**RE: Bronco Utah Operations LLC
Emery Mine
DOGM Permit No. C/015/0015
Emery 2 Full Extraction Revision**

Title: Emery 2 Full Extraction

Pre-Subsidence Survey Prior to Full Extraction, Emery 2 Portal, South of Quitchupah Creek

Inserted 10/2018

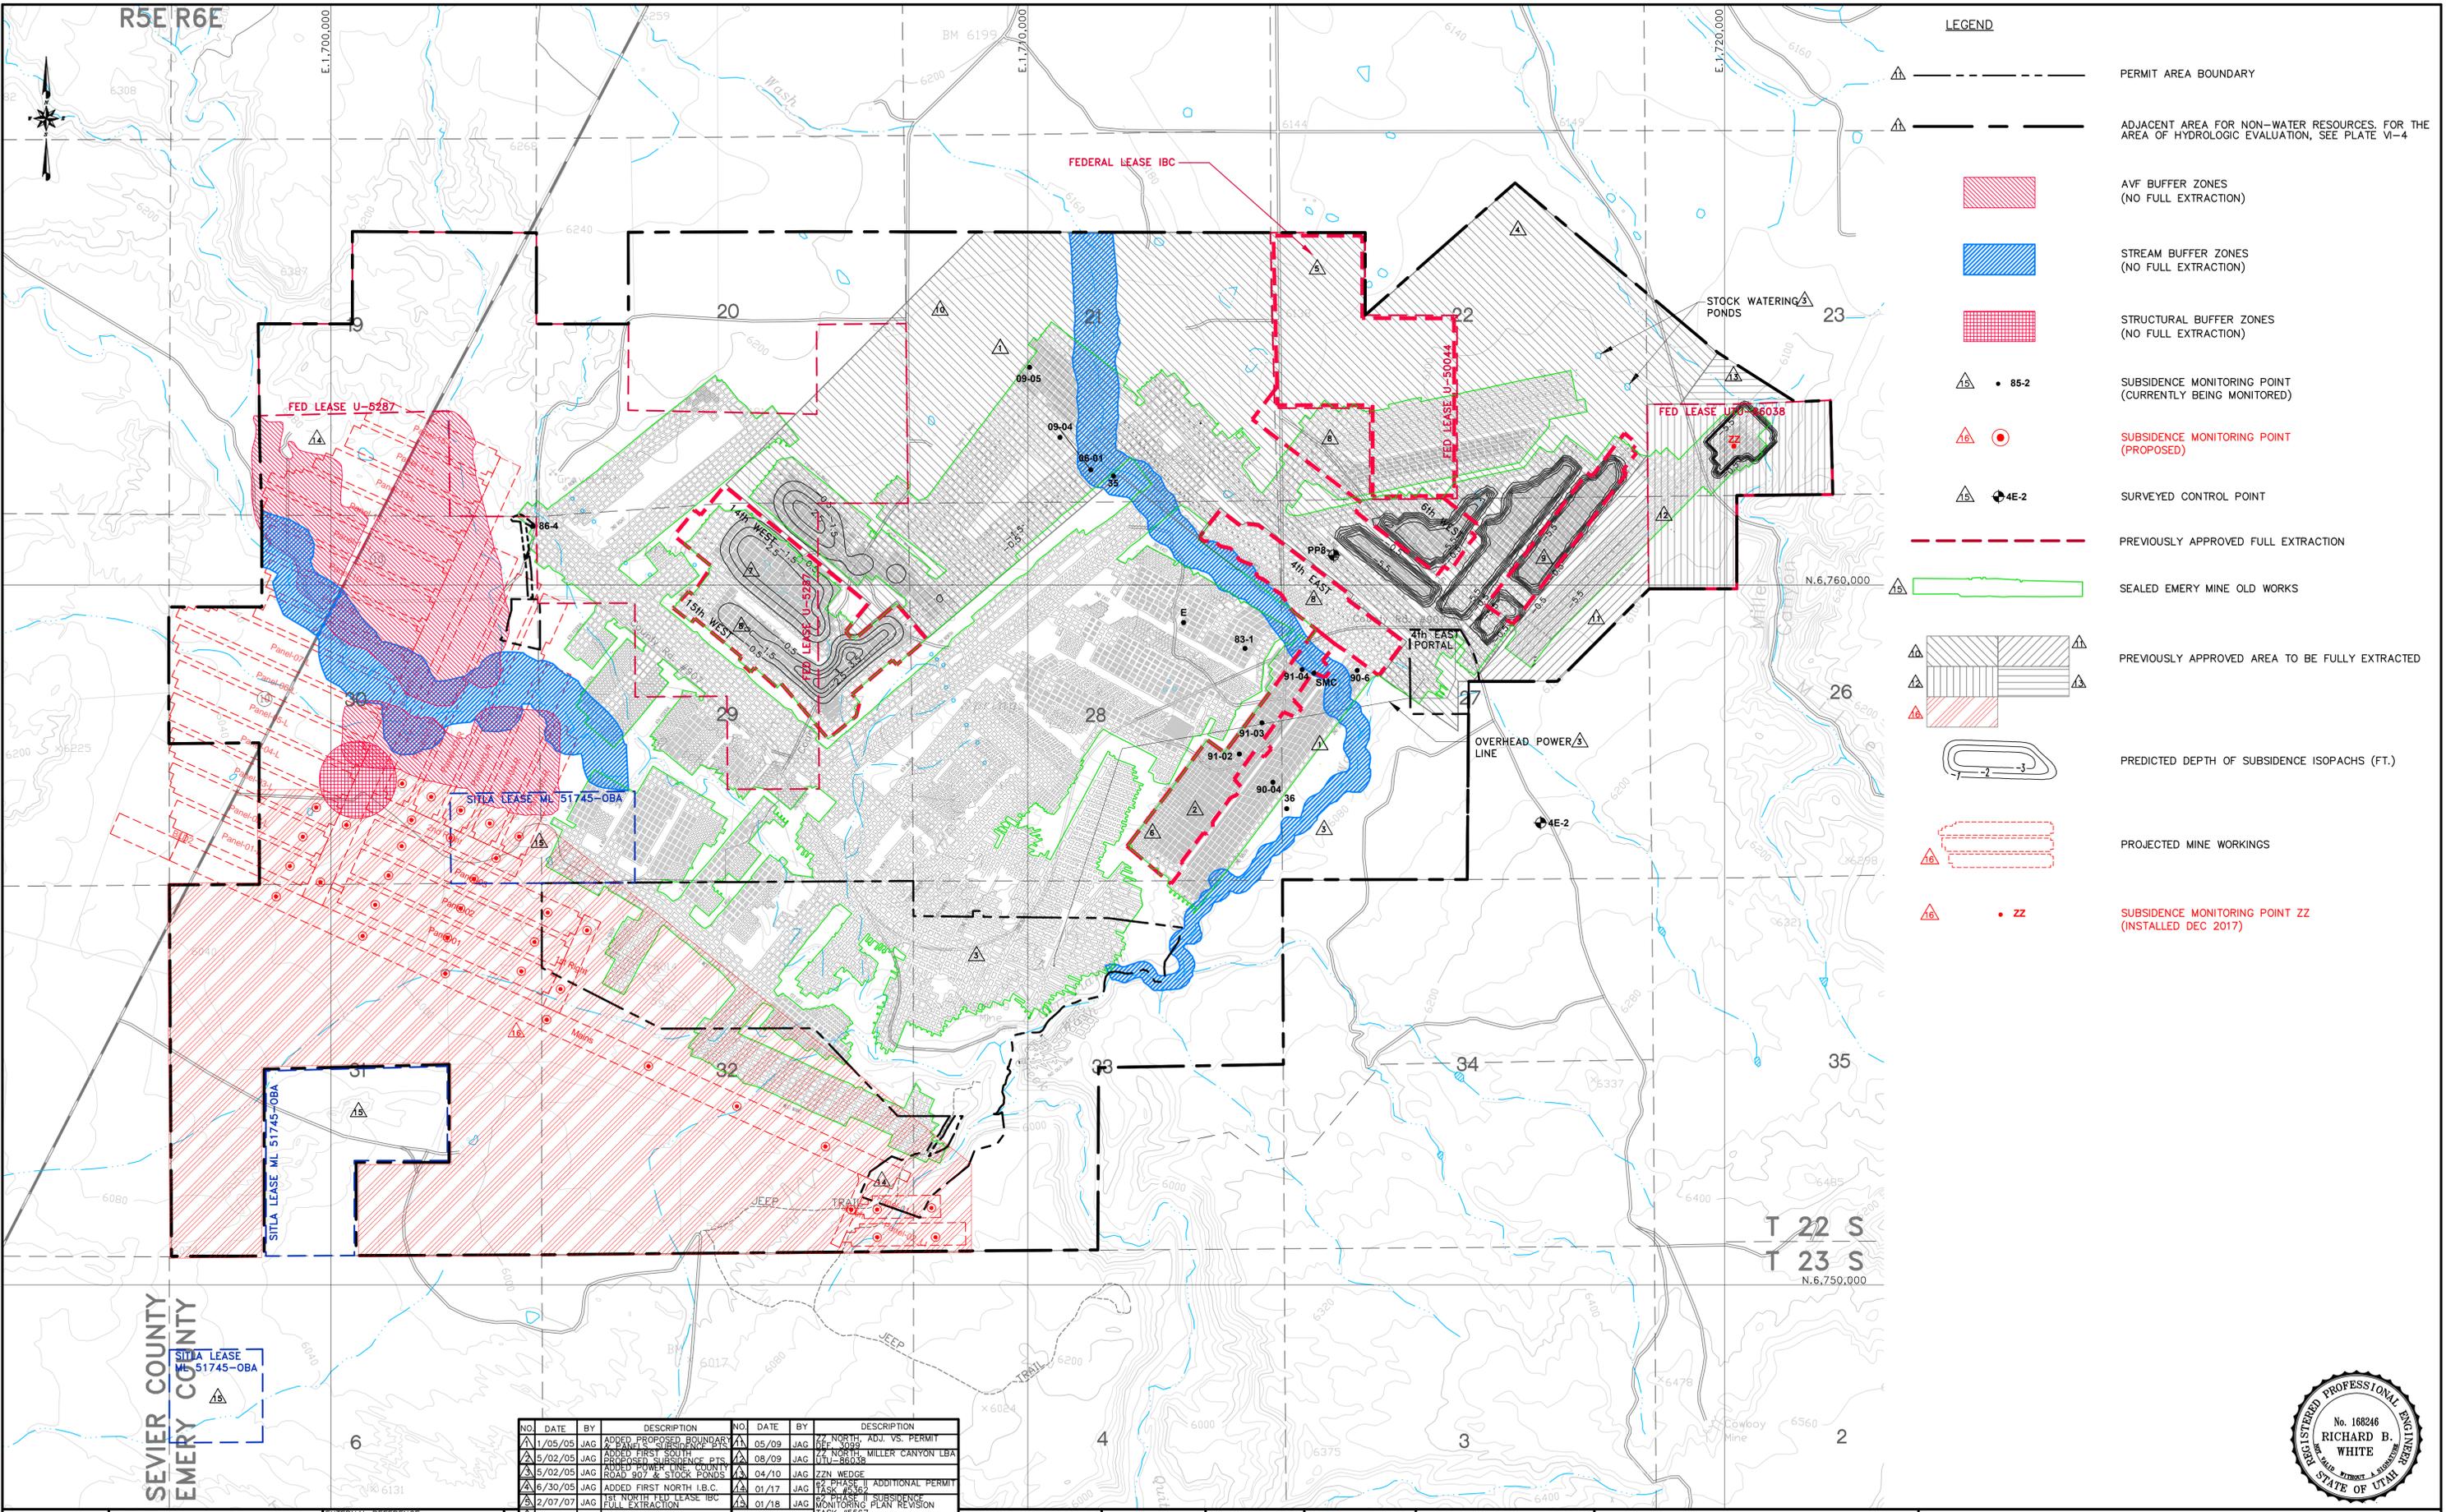
This submittal updates a previous pre-subsidence survey on the surface south of Quitcupah Creek and requests approval to conduct full extraction mining and planned subsidence of the surface. Surface owner agreements will be obtained prior to any full extraction within a given tract not controlled by Bronco.

<input type="checkbox"/> Add	<input type="checkbox"/> Replace	<input type="checkbox"/> Remove	
<input type="checkbox"/> Add	<input checked="" type="checkbox"/> Replace	<input type="checkbox"/> Remove	CH V Plate V-5 Subsidence Monitoring Points and Buffer Zones
<input type="checkbox"/> Add	<input type="checkbox"/> Replace	<input type="checkbox"/> Remove	
<input type="checkbox"/> Add	<input type="checkbox"/> Replace	<input type="checkbox"/> Remove	
<input type="checkbox"/> Add	<input type="checkbox"/> Replace	<input type="checkbox"/> Remove	
<input type="checkbox"/> Add	<input type="checkbox"/> Replace	<input type="checkbox"/> Remove	
<input type="checkbox"/> Add	<input type="checkbox"/> Replace	<input type="checkbox"/> Remove	
<input type="checkbox"/> Add	<input type="checkbox"/> Replace	<input type="checkbox"/> Remove	
<input type="checkbox"/> Add	<input type="checkbox"/> Replace	<input type="checkbox"/> Remove
